## SUBMITTAL SUMMARY REPORT MajorSite-000718-2026

<b>PLAN NAME:</b>	Lockheed Martin Training Village and Building 12 Renovation	<b>LOCATION:</b>	331 CYPRESS RD OCALA,
<b>APPLICATION DATE:</b>	04/30/2026	<b>PARCEL:</b>	9014-0044-05
<b>DESCRIPTION:</b>	As directed by Marion County, this is a submittal for a revision to approved major site plan AR# 19613. This project proposes the construction of modular training buildings and a building expansion for Lockheed Martin.

SHEET NUMBER  
**C04.01**

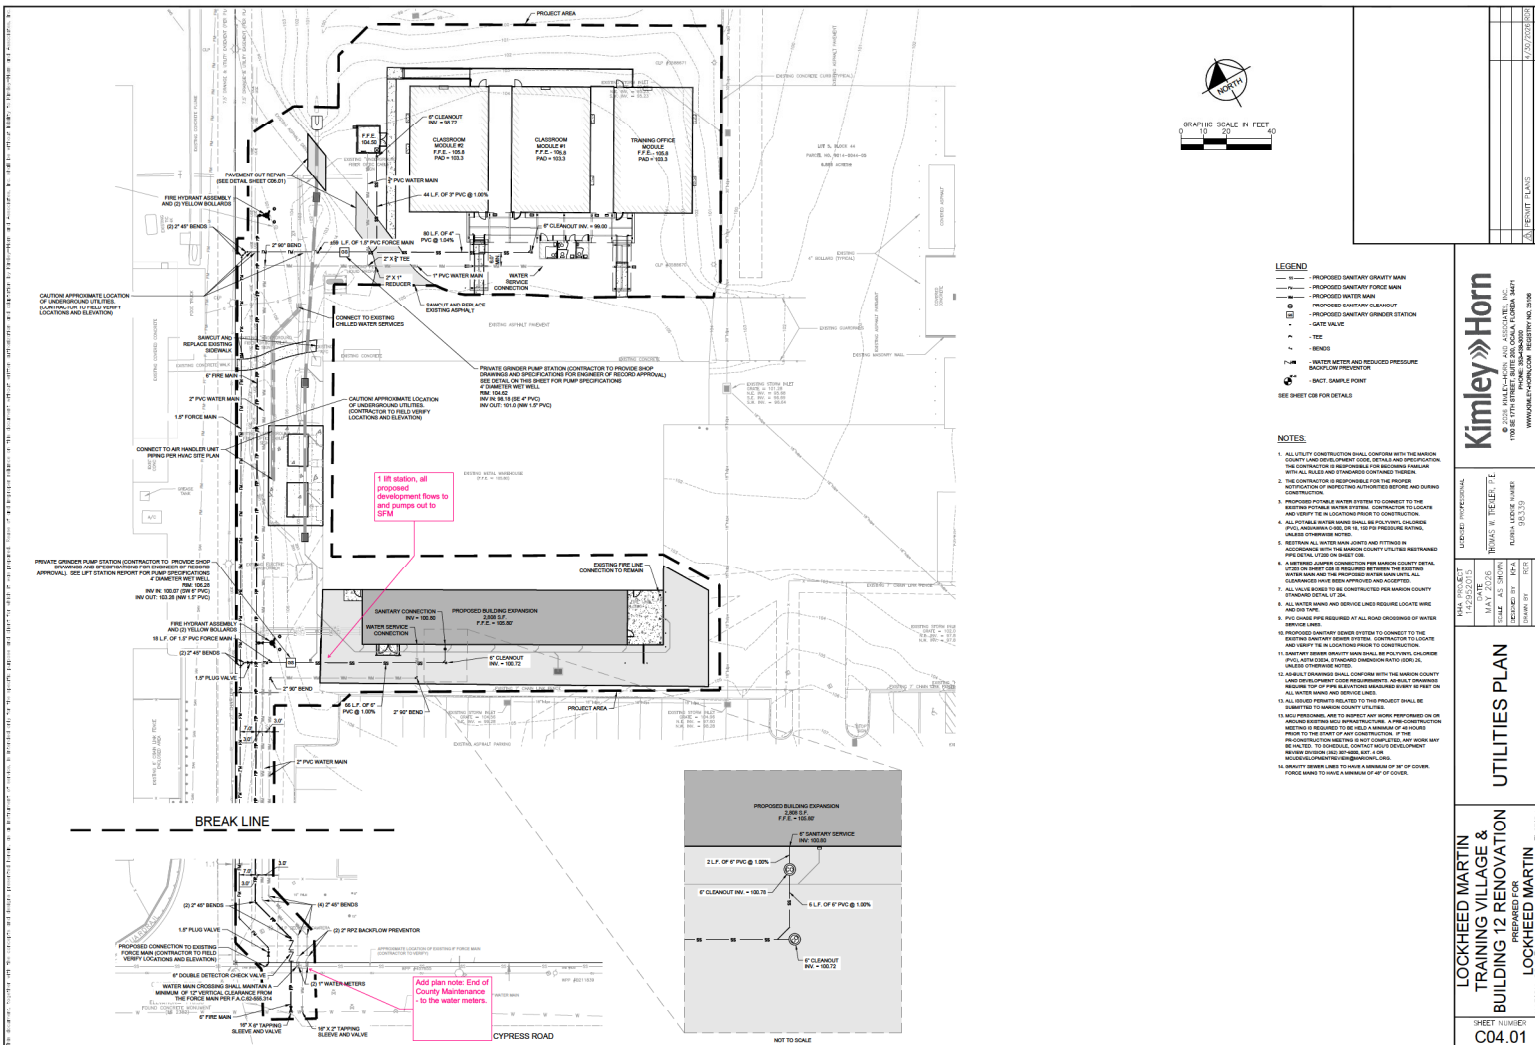
<i>Corrections</i>	6.14.5.A(8) - Connection to existing sanitary ( <b>Resolved</b> ) - <b>Corrective Action:</b> See plan mark-ups. Need to show water and sewer connections on Cypress Rd in the ROW, with end of county maintenance plan notes. - 6.14.5.A(8) - Connection to existing sanitary:			
<i>Corrections</i>	6.15.6.C - Sewer service only ( <b>Resolved</b> ) - <b>Corrective Action:</b> 6/22/26 Needs to be a 2" plug valve at the property line and a 2" FM until the connection. Previous comment C04.1 - Show the existing FM with size. (2) Add profile of crossing. Show the method of connection. (3) Plug valve needed at FM and Property line. (4) Plan Note: End of County Maintenance - at plug valve at property line. - 6.15.6.C - Sewer service only:			
<i>Corrections</i>	6.14.9.A - Developer's Agreement ( <b>Resolved</b> ) - <b>Corrective Action:</b> Not applicable. - 6.14.9.A - Developer's Agreement:

<i>Corrections</i>	6.14.5.A(2) - Proposed mains & connections shown ( <b>Resolved</b> ) - <b>Corrective Action:</b> See plan mark ups. - 6.14.5.A(2) - Proposed mains & connections shown: Proposed mains shall be marked as private or public (MCU); points of demarcation shall be called out as necessary to identify changes in ownership. Shall include profile views unless otherwise noted.			
<i>Corrections</i>	6.14.9.B - Transfer of Assets to MCU - PLAN NOTE: ( <b>Resolved</b> ) - <b>Corrective Action:</b> Add plan note: Any assets to be conveyed to Marion County Utilities as part of the public utility system shall be coordinated PRIOR TO Marion County Utilities through the Bill of Sale, and prior to MCU's authorization of the DEP connection/Clearance Package. The Bill of Sale for any Lift Station(s) MUST include the first electric bill to capture necessary data prior to transfer to Marion County Utilities. ALLOW A MINIMUM OF 5 WORKING DAYS for processing the Bill of Sale information. - 6.14.9.B - Transfer of Assets to MCU - PLAN NOTE:

1 fire station, all proposed development flows to and pumps out to SFM

Add plan note: End of County Maintenance to the water meters.
